FirstEnergy Nuclear Operating Company

Subject:
Davis-Besse Nuclear Power Station
Docket No. 50-346, License No. NPF-3
License Amendment Request To Revise Emergency Diesel Generator Minimum
Voltage Surveillance Requirements, and Add Figure Axis Labels

Subject: License Amendment Request to Revise the Emergency Diesel Generator
Minimum Voltage Surveillance Requirements, and Add Figure Axis Labels

Figure 3.7.18-1 (page 1 of 1)
Maximum Allowable Steam Generator Level

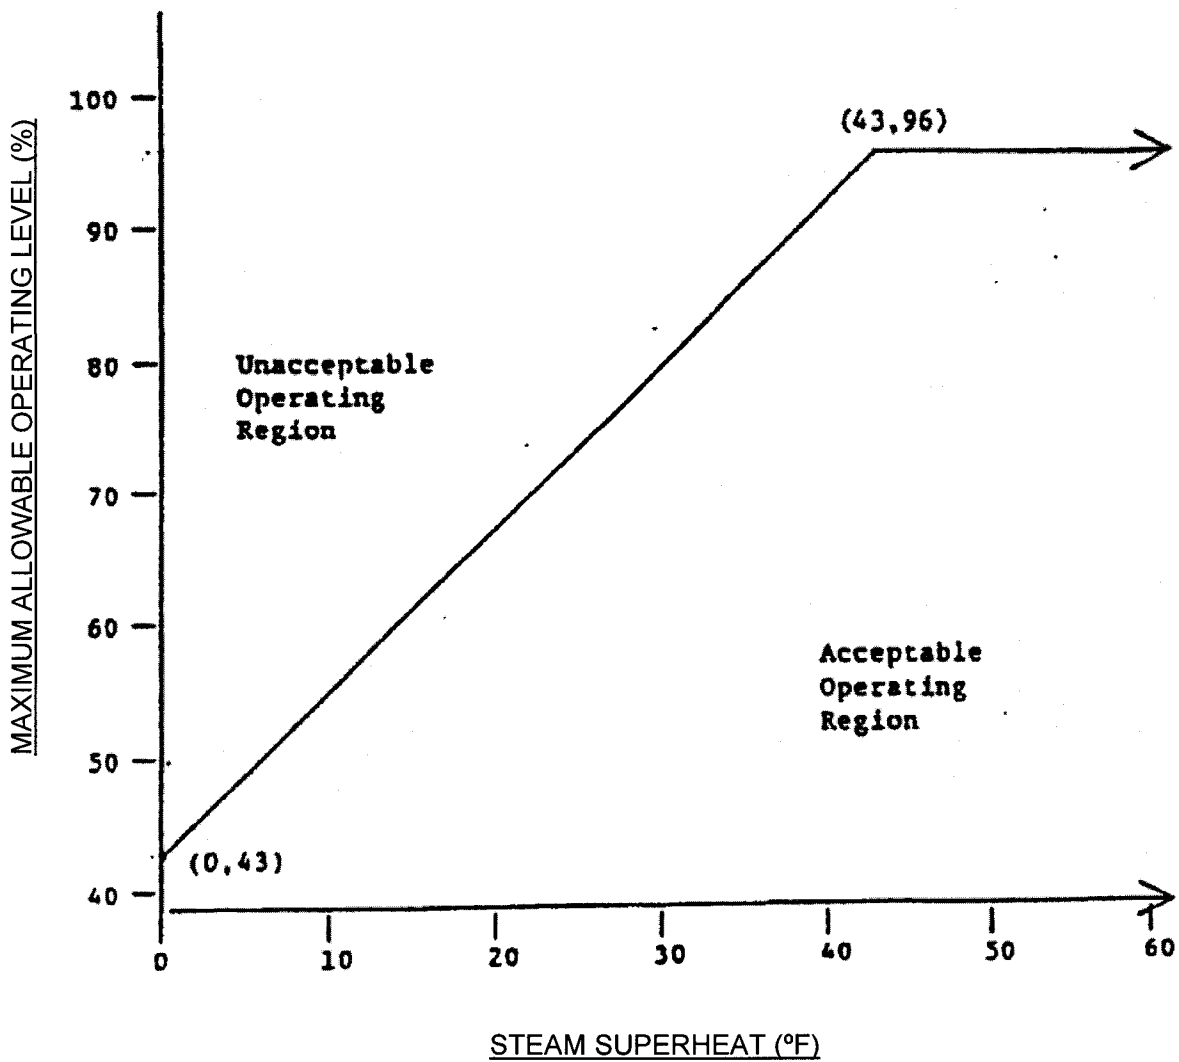
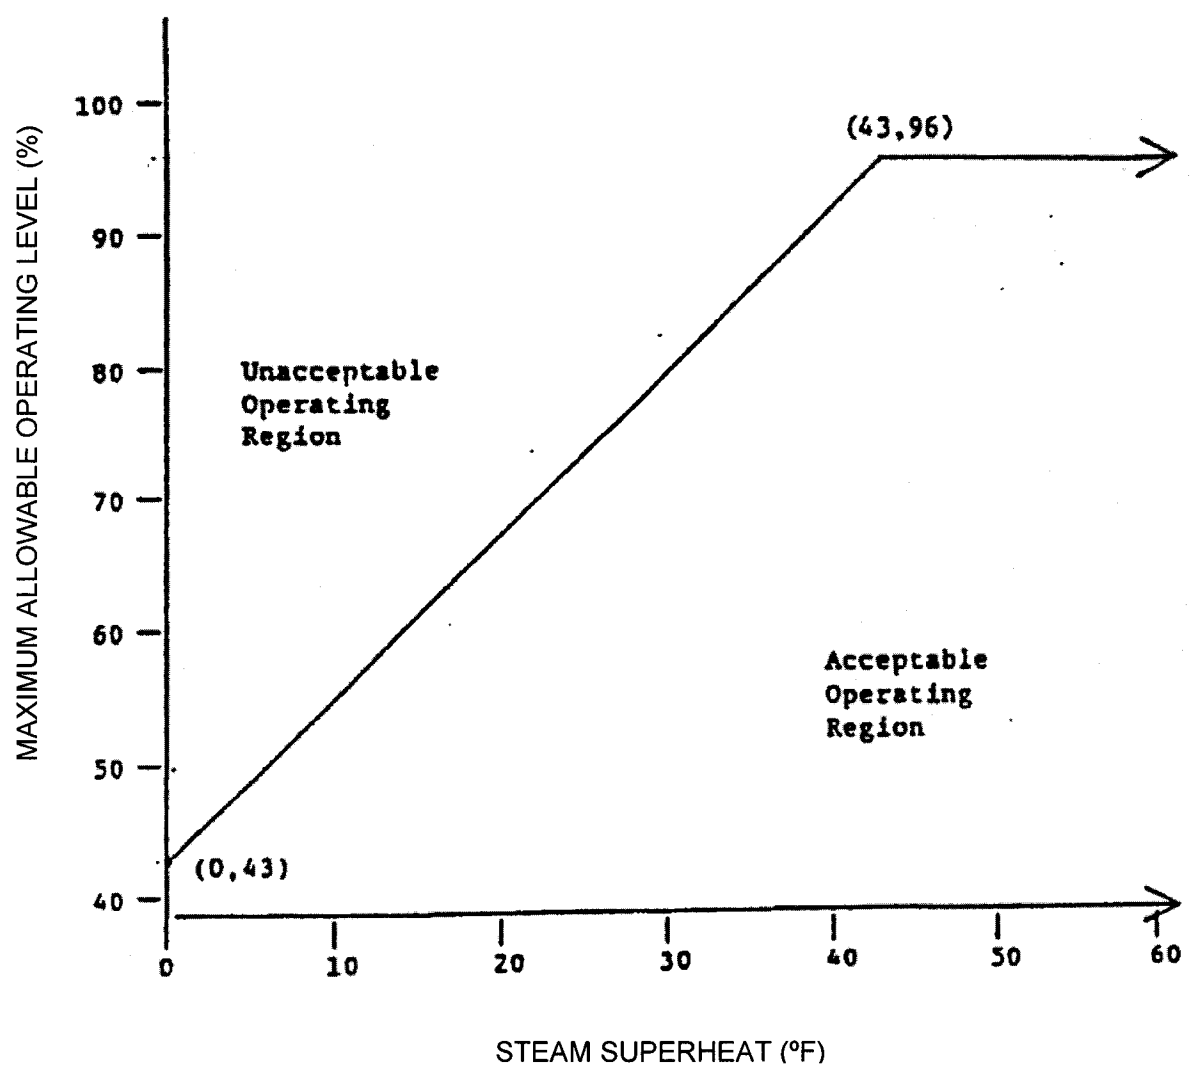
The following X and Y axis labels will be added to Technical Specification Figure 3.7.18-1.

X axis label: STEAM SUPERHEAT ($^{\circ}$ F)

Y axis label: MAXIMUM ALLOWABLE OPERATING LEVEL (%)

The line chart shown in Technical Specification Figure 3.7.18-1 was revised as part of the conversion to the improved technical specifications and submitted in Attachment 1 of a supplement letter dated August 7, 2008 (Reference 2). The change to add axis labels corrects the inadvertent omission of the labels when Figure 3.7.18-1 was submitted in a letter dated October 21, 2008 (Reference 3) with the final copy of the improved technical specifications.

The proposed addition of axis labels to Technical Specification Figure 3.7.18-1, "Maximum Allowable Steam Generator Level" is an administrative change to reflect the axis labels proposed during the conversion to improved technical specifications, but inadvertently omitted when the final typed pages were forwarded to the NRC before the amendment was issued.
